Discussion Issues on DPPS Testing

4th DPPS TF Meeting, 2017.11.21~23

**Ministry of Land, Infrastructure and Transport
Korea Transportation Safety Authority,
Korea Automobile Testing & Research Institute**

Issues on test area with a deployed hood

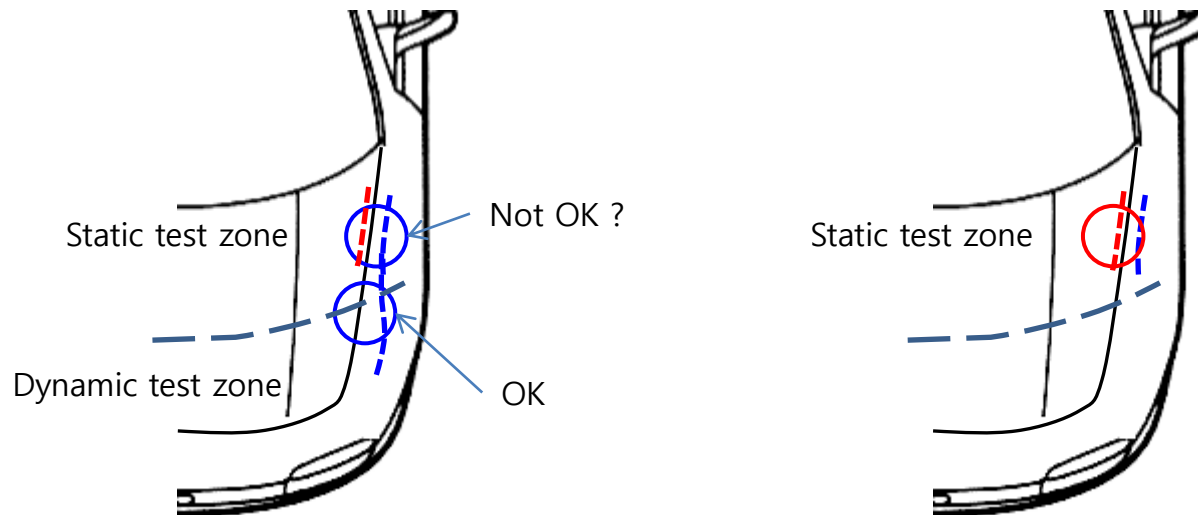
■ ISSUE 6

- What if the test area would be extended rearward in the future?
 - How to define the test area with a deployed hood?
 - Various considerations (WAD, Impact points, etc.)

Issues on deployable hood height

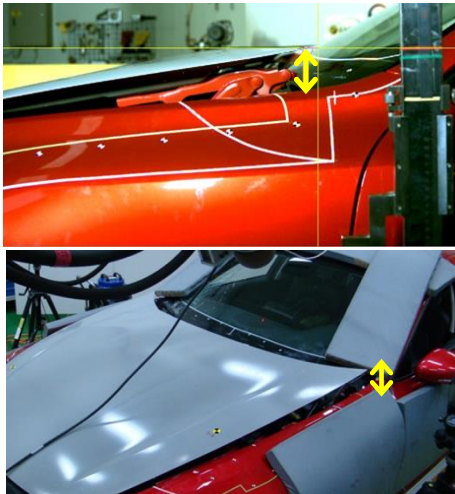
■ ISSUE 8

- Difference between the valid height for measuring TRT and the actual height of deployed hood in headform testing
